SECTION 8.00-9.00 Planning Pre-App’s DM/23/1480 & DM/25/0133

Responses to and Comparables with Current Full Planning/Listed Building Consent Applications

8.00 Pre App DM/23/1480 and Current Proposal Responses & Comparables

8.03 Proposed Reading Nook (C1) & Second Floor Bedroom 13 (C2)

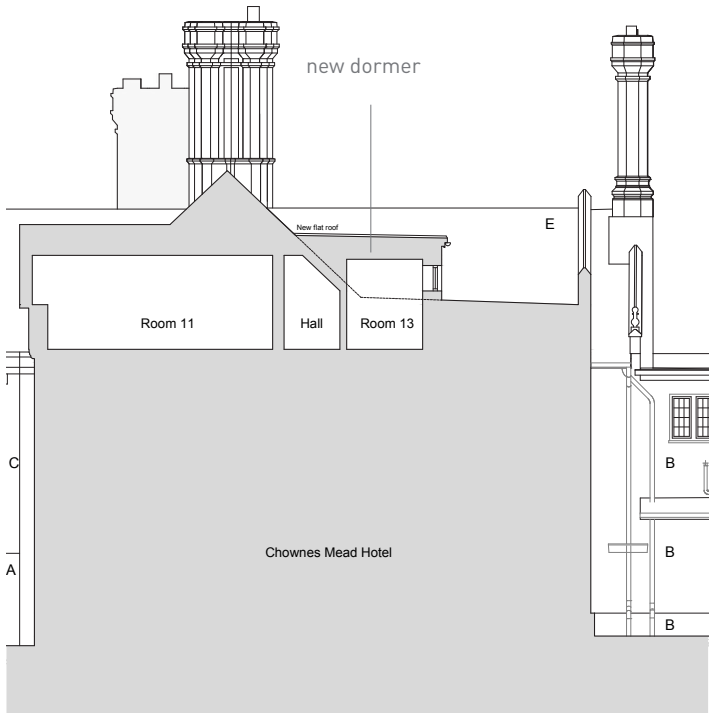
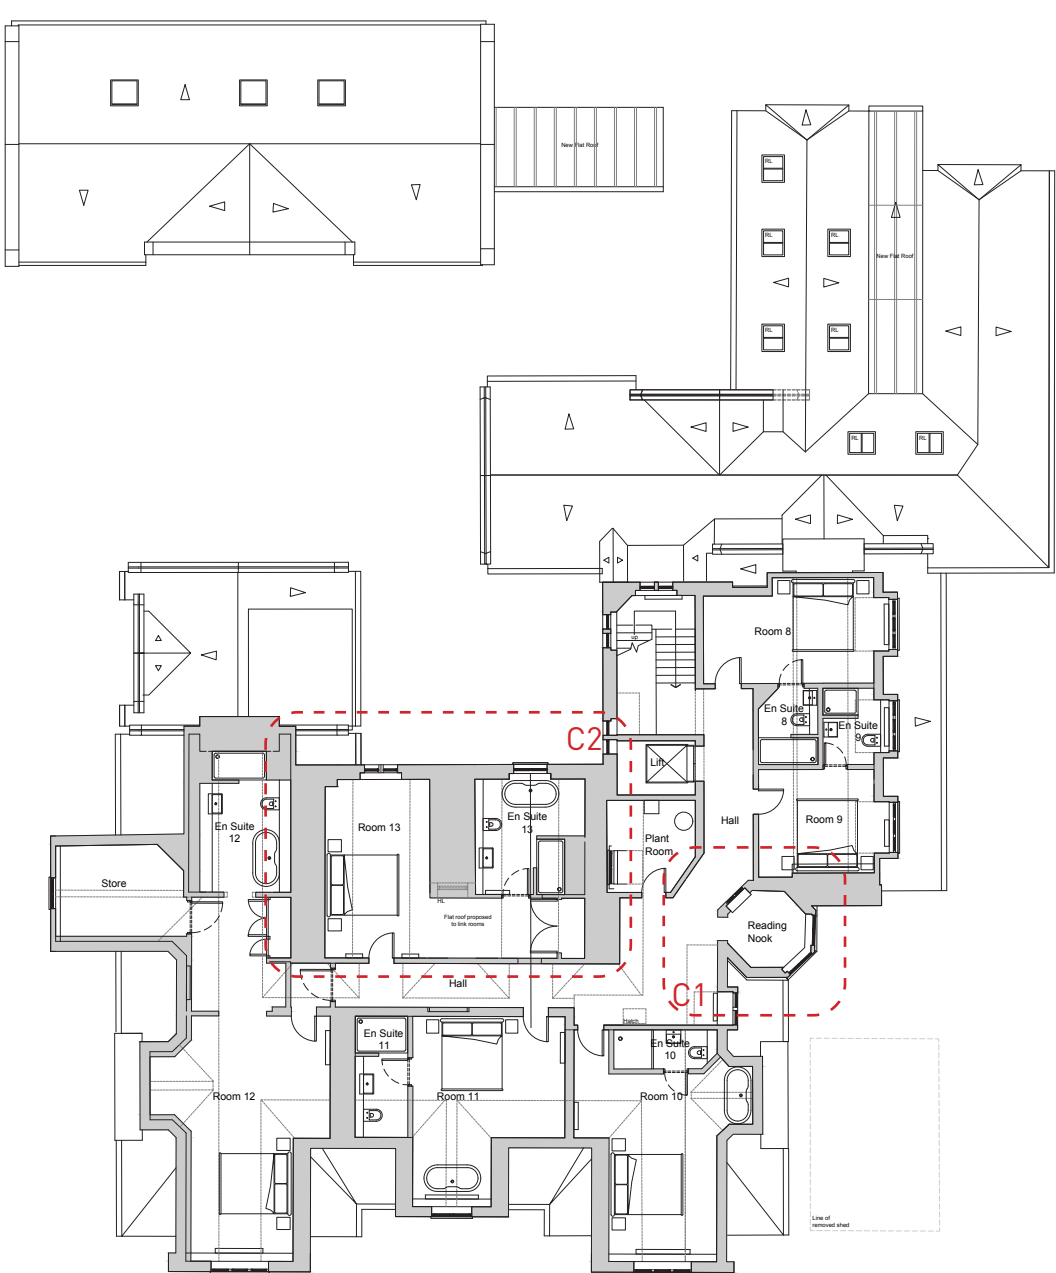
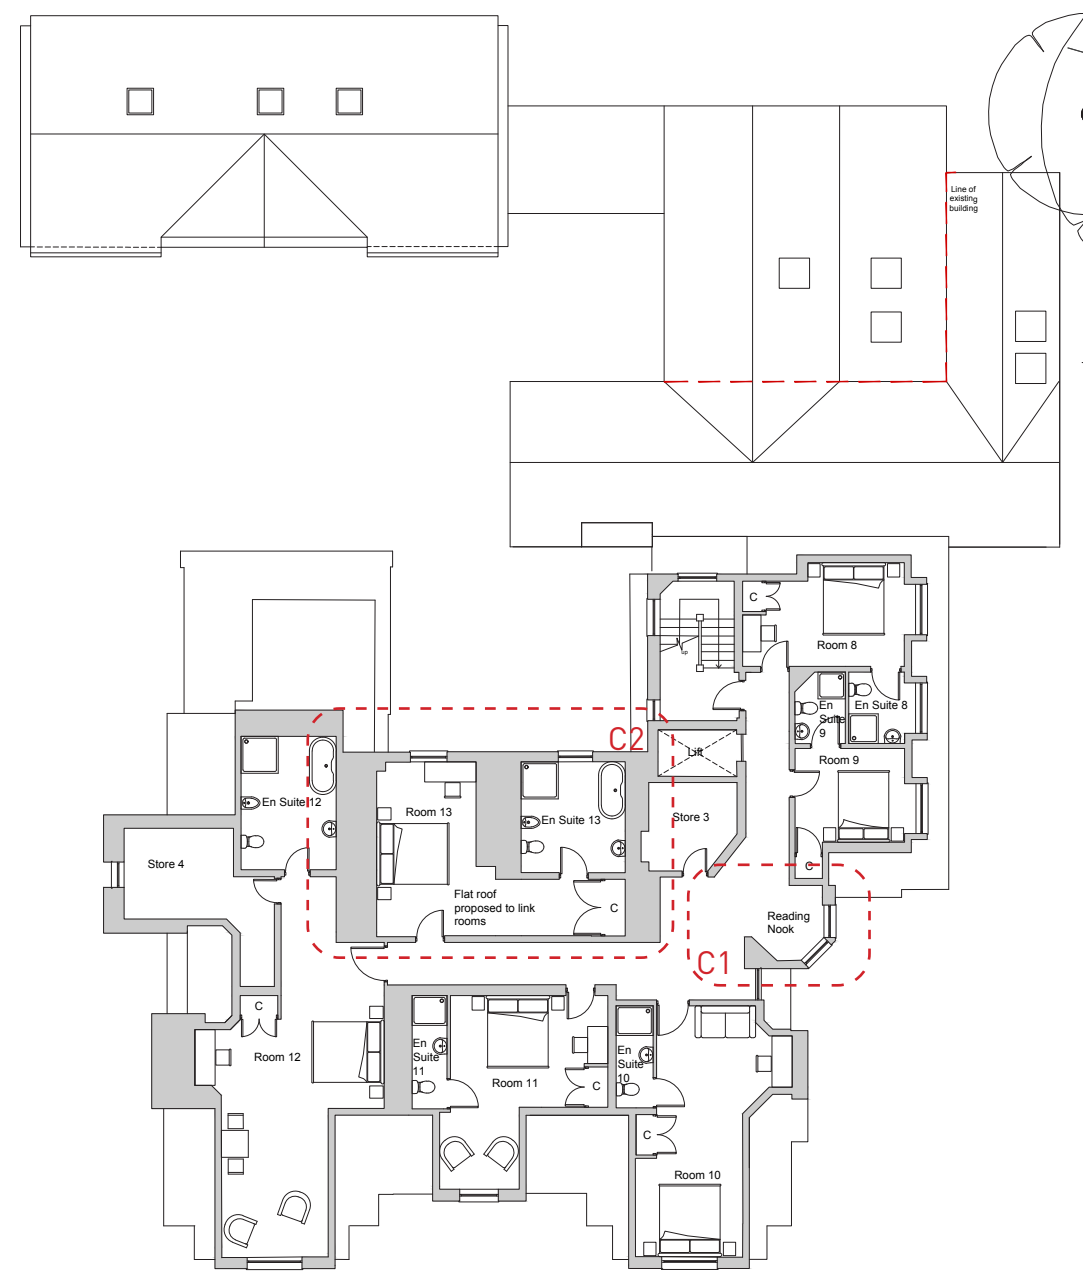
C1
“The proposal also shows the removal of wall enclosing the proposed ‘reading nook’- this would result in an unacceptable loss of historic plan form and fabric and I would suggest should be omitted from the scheme.”

C2
“At second floor, the majority of works relate to the insertion of ensembles to the existing attic bedrooms. Although this will have some impact on their proportions, given the secondary importance of these spaces this aspect of the proposal is on balance considered acceptable. It is also proposed to alter the roof form above the existing kitchen and adjacent bathroom/ walk through cupboard space to create an area of flat roof which allows the formation of a link between the spaces, to provide an additional ensuite bathroom. Further detail including proposed sections, elevations and a roof plan would be needed for fully informed comment, however in principle this may be acceptable, provided that there is no adverse impact on the external appearance of the building, and that as discussed on site, the internal character of the adjacent corridor, with the angled intrusions revealing the shape of the original roof above, is preserved. The level of interest of the joinery within the walk through cupboard space should also be considered- it is proposed to partially remove this, which is work which should be assessed in an accompanying heritage statement, and if necessary amendments- such as the reuse of the joinery in question elsewhere in that room - considered.”

C1
The comments of the LPA re. the pre-app proposal to remove part of the wall enclosing the proposed reading nook are acknowledged and thus this area will remain as existing.

C2
The comments of the LPA re. the pre-app proposal for the removal of part wall (including cupboards) to form a link between kitchen and bathroom are acknowledged. Proposed sections and elevations are included within the planning application package which shows no adverse impact on the listed building. The new link will have a traditional lead rolled flat roof over and this will be considerably withdrawn towards the rear of the section of roof set back behind the primary rear double gables. The new roof will not be visible from courtyard area at the rear. The existing joinery is not believed to be of significant heritage value, and it is not proposed to reuse these within the new proposals in a specific location. However they may be re-purposed in storage areas if appropriate.

8.04 New Leisure Facilities - Pool/Spa/Gym/ Yoga: Lower Ground / Ground Floor (nts)

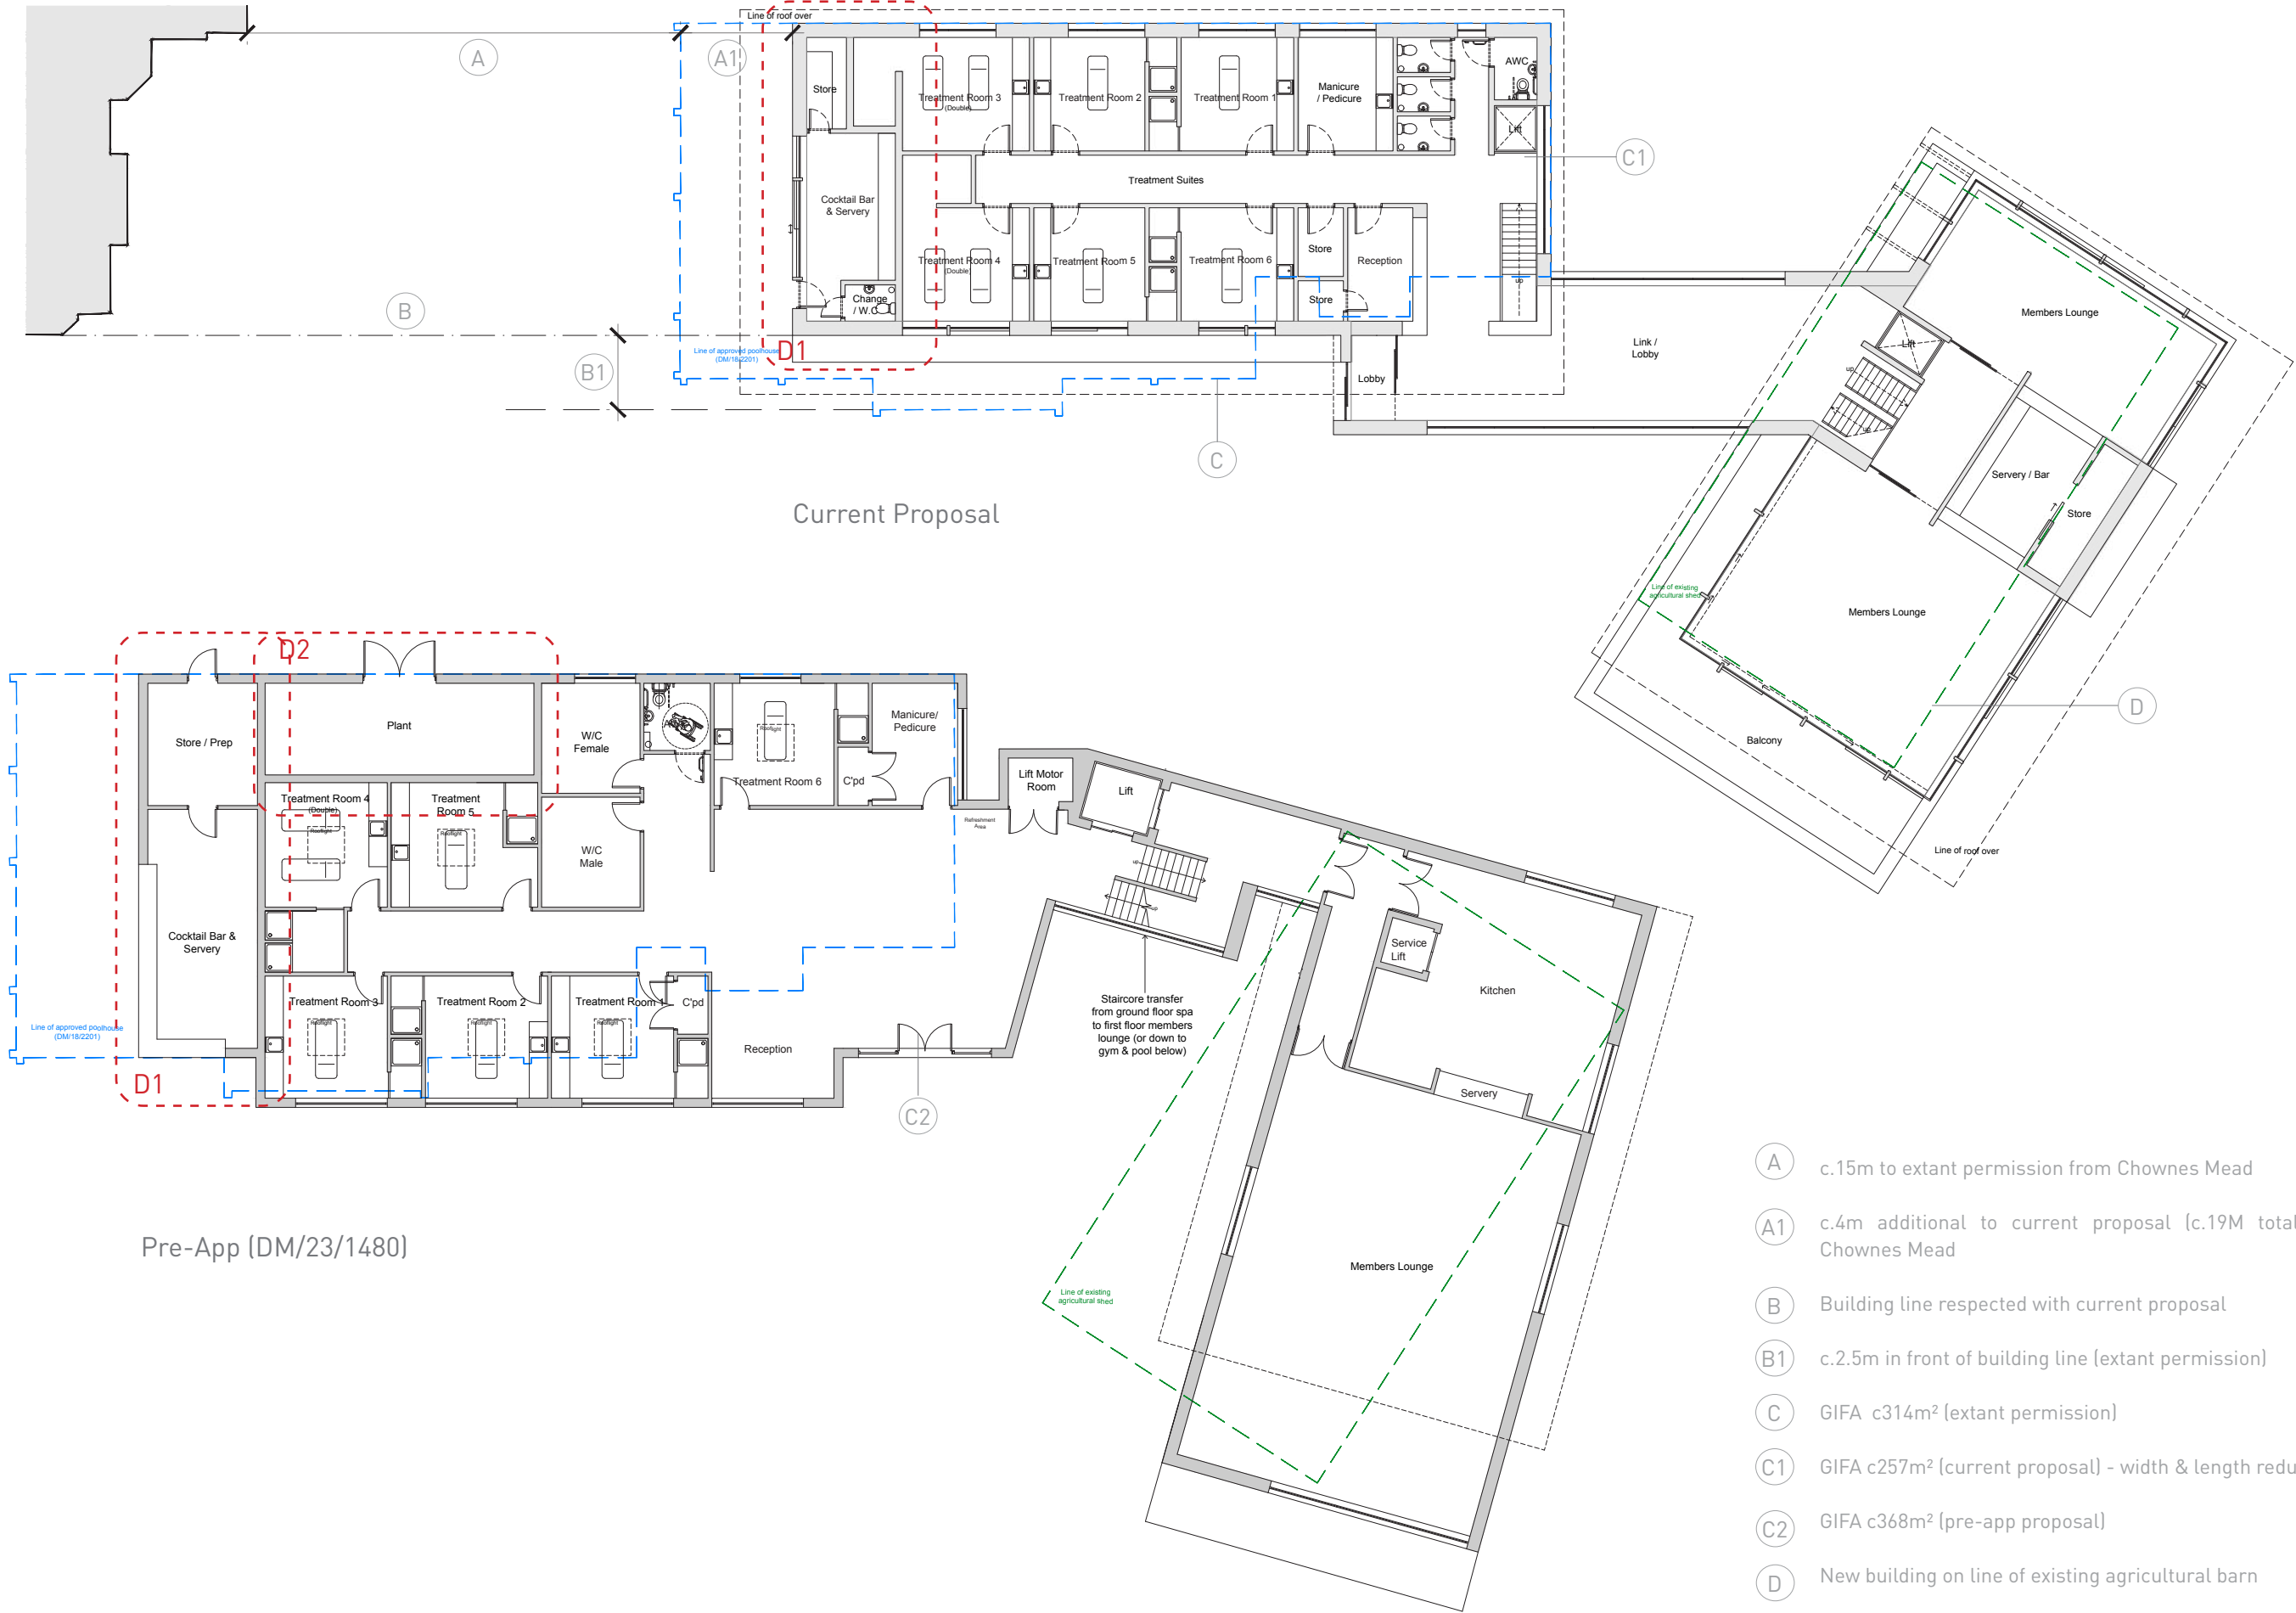
D1
‘The proposed two storey pool and treatment room building is a more substantial structure than the approved pool house. However, the building is set further away from the listed house, creating greater separation between the two, and the additional storey is set below the terrace, taking advantage of the drop in the levels of the gardens to the south west of the house.’
‘In my opinion, this approach is not necessarily contentious in principle, but the building and surrounding landscaping will require very careful planning and detailing, including the choice of materials, to minimise the bulk and visual prominence of the development in the context of the house, ensure that it complements rather than detracts from the house and its setting, and to preserve the character of the Jekyll designed gardens, including the existing listed terrace walls. The submitted visuals, which I appreciate are only conceptual, show for example a rather stark treatment of the retaining wall to the north west of the pool house itself, continuing along the house’s garden frontage. We would expect a more sensitive treatment with appropriate detailing and planting to blend the built form into the landscape, and not to detract from or compete with the original listed terrace walls. I also wonder whether the cocktail bar and servery to the north west end of the ground floor of the building is necessary in this form and position, particularly given the proximity of the house, or could be omitted or relocated to reduce the bulk of the building.’

D2
‘Firstly, I do have concerns about the potential noise generated by the plant associated with the spa and gym. To adequately assess this issue, we would require detailed information about the proposed plant, its location, whether it is internal or external, and any measures that will be implemented to mitigate noise. Depending on the expected noise breakout, we may need to request an acoustic report to ensure that the noise levels will not adversely affect the surrounding area.’

D1
Subservience & Separation
As noted in the pre-app response, the upper level of the proposed spa and pool building is set c.4M further away from the listed building than the extant permission. The intention is to create a greater separation between existing and new build elements, reinforcing the subservience of the new buildings, the current proposal widening this gap to c.19M overall.

D2
The refined and reduced layout of the treatment suites and pool / spa building has enabled a reworking of the plant areas which were positioned towards the north west end of the building at the upper floor level in the pre-app submission. The current layouts propose repositioning this element below ground to the south eastern end of the building to mitigate any noise breakout impacts from the plant area that would potentially impact the guests of the listed building or neighbours.
